Form 3160-5
(June 2019)UNITED STATES
DEPARTMENT OF THE INTERIOR
BUREAU OF LAND MANAGEMENTFORM APPROVED
OMB No. 1004-0137
Expires: October 31, 2021**SUNDRY NOTICES AND REPORTS ON WELLS**
Do not use this form for proposals to drill or to re-enter an abandoned well. Use Form 3160-3 (APD) for such proposals.

8. Well Name and No. HAWK 35 FED/507H

Hawk 35 Fed 408H (FKA 507H) API #: 30-025-47906

EOG respectfully requests an amendment to our approved APD for this well to reflect the following changes:

WELL LOCATION AND ACREAGE DEDICATION PLAT

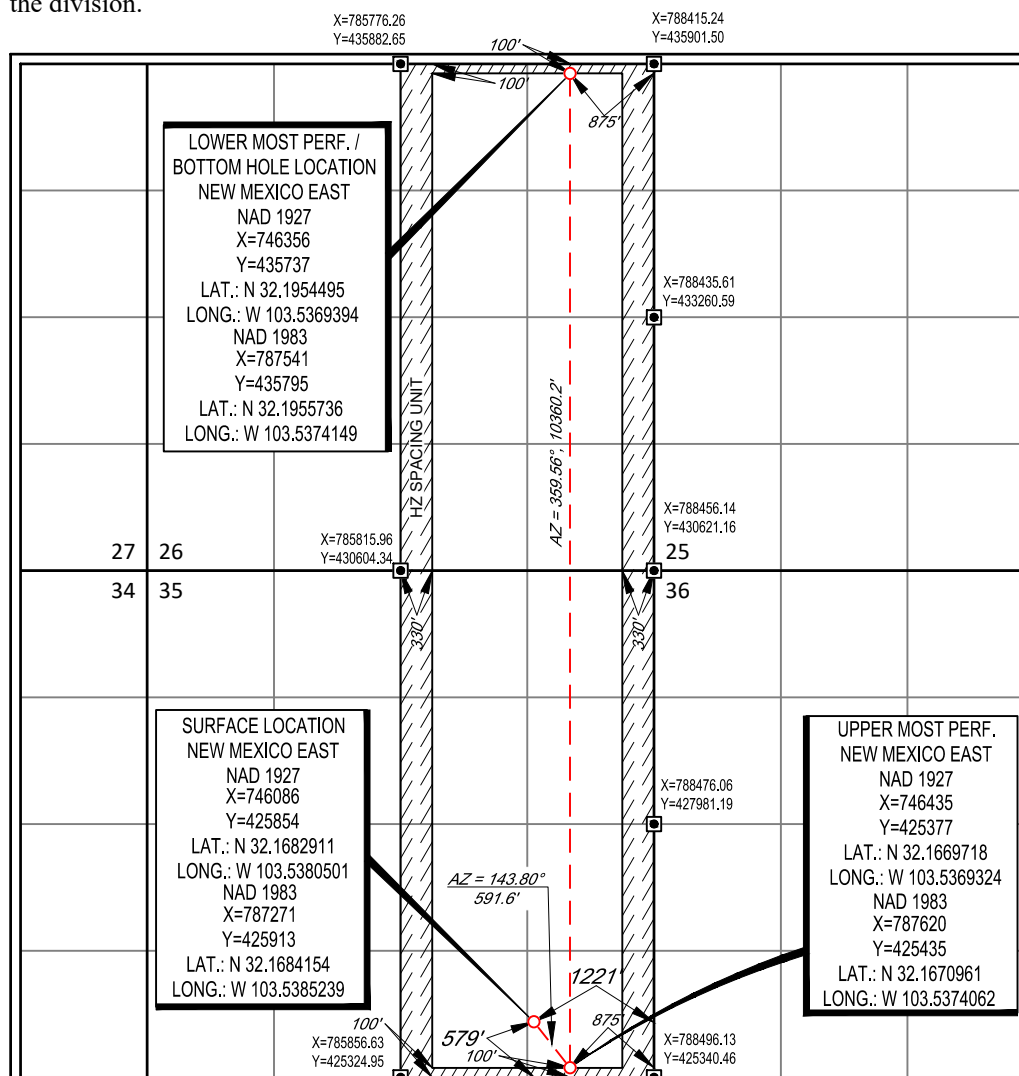
Change BHL from T-24-S, R-33-E, Sec 26, 100' FNL, 990' FEL, Lea Co., NM,
to T-24-S, R-33-E, Sec 26, 100' FNL, 875' FEL, Lea Co., N.M.

UL or lot no.	Section	Township	Range	Lot Idn	Feet from the	North/South line	Feet from the	East/West line	County
A	26	24-S	33-E	—	100'	NORTH	875'	EAST	LEA
